TELEPRINTER WORKING AT NON-PANEL MOUNTED OFFICES. TG(L) 1044.

DUPLIX CIRCUIT WITH SWITCH TO RESERVE FACILITY.

3-7-36.

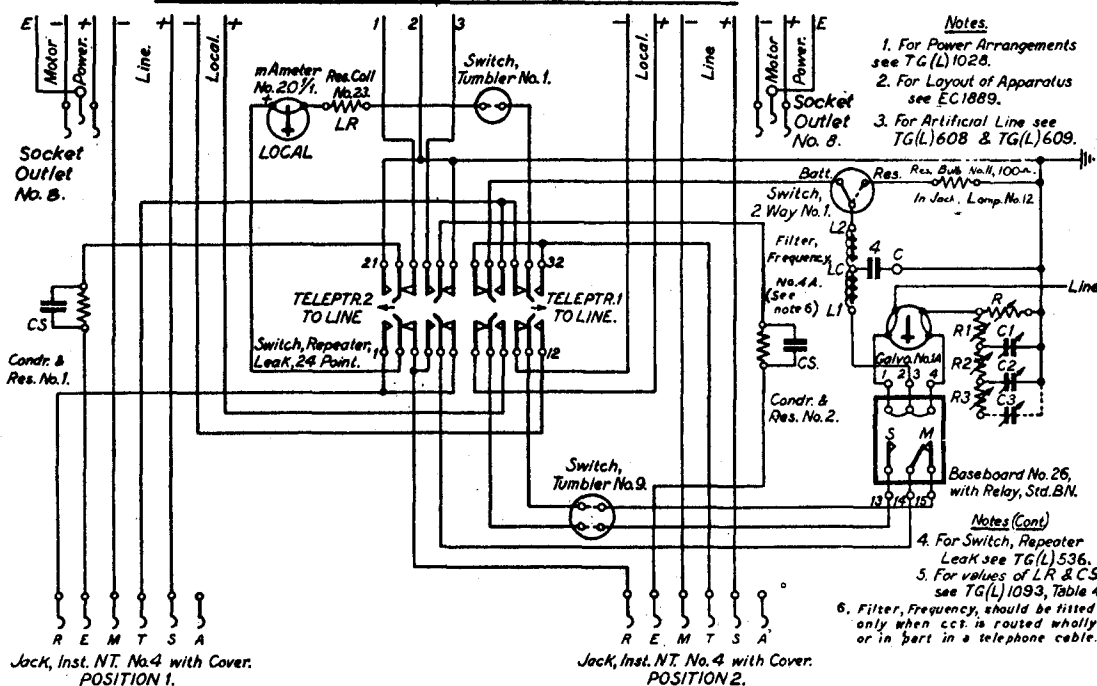
Res. Coil No. 23 was BC. No. 1
 Res. Bulb No. 11 was Res. Coil No. 3
 Socket Outlet No. 8 was PW No. 8 & S.S.
 Note 2 EC project deleted. See 3-1-39. B.
 L.M. was A1039 Power of X B-10-37. A.
 A Socket Outlet No. 8.
